SUBJECT: Nexen Energy ULC Flemish Pass Exploration Drilling Project – Information Requirements

Attachment 1 - Information Requirements and Required Clarifications for the Nexen Energy ULC Flemish Pass Exploration Drilling Project.

**Nexen Energy ULC Flemish Pass Exploration Drilling Project
Information Requirements and Required Clarifications from Environmental Impact Statement Review:
June 8, 2018**

Appendix A - Hovmöller plots

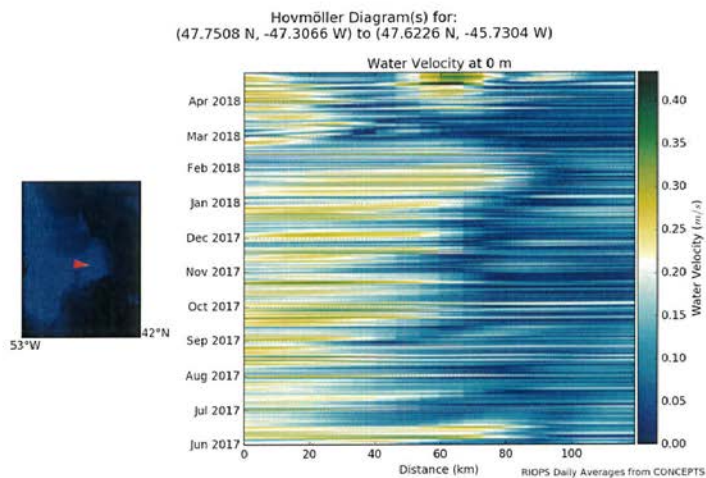
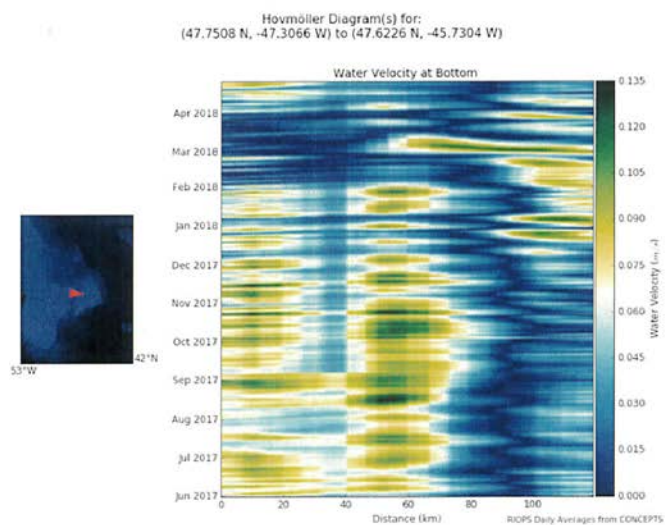
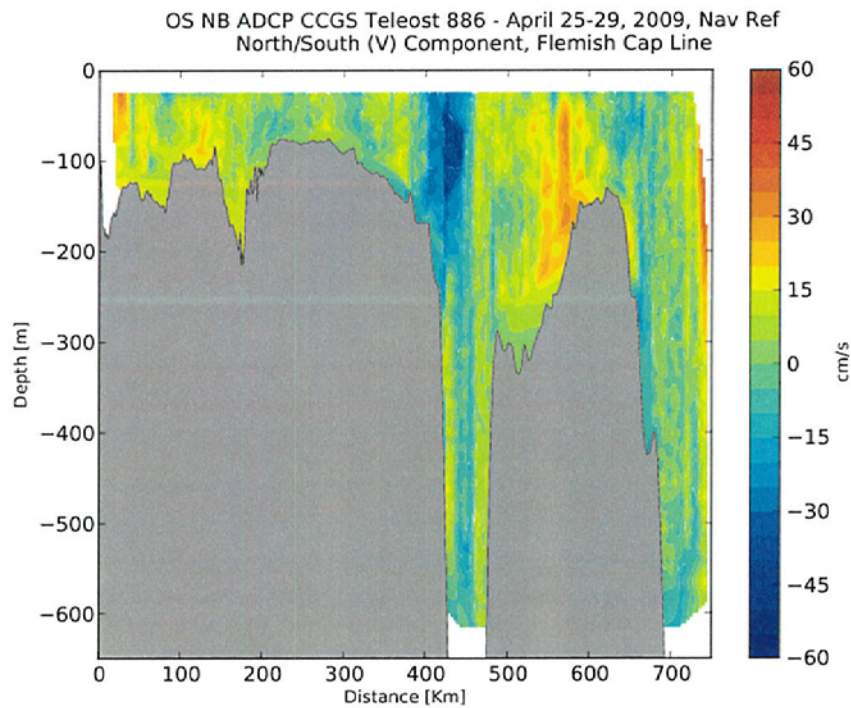
CL-26	DFO-02- Nx; DFO- 34-Ax-Nx	5(1)(a)(i) Fish and Fish Habitat 5(1)(a)(ii) Aquatic Species	Part 1, section 4.3 Study Strategy and Methodology.	Page 954, section 16.4.3 Model Input Data; Appendix G – Section 3.5 Currents	The EIS does not provide sufficient rationale for the selection of the oceanographic inputs in the models used compared to other available datasets, including inputs used for the spill trajectory model. The EIS states that, “[w]hile this subset of data is not the most recent five years of data, currents and winds in the study area are very similar to those from 5-10 years ago and the data used in this study would be representative of environmental conditions present today.”	Provide rationale that the data inputs used are applicable and best suited to modelling in the Project Area, with consideration of predicted future conditions sufficient to provide a degree of certainty or validation in the predictions made, and provide a margin of error associated with the predictions. Provide additional justification for use of datasets from 2006-2010, including appropriate references.
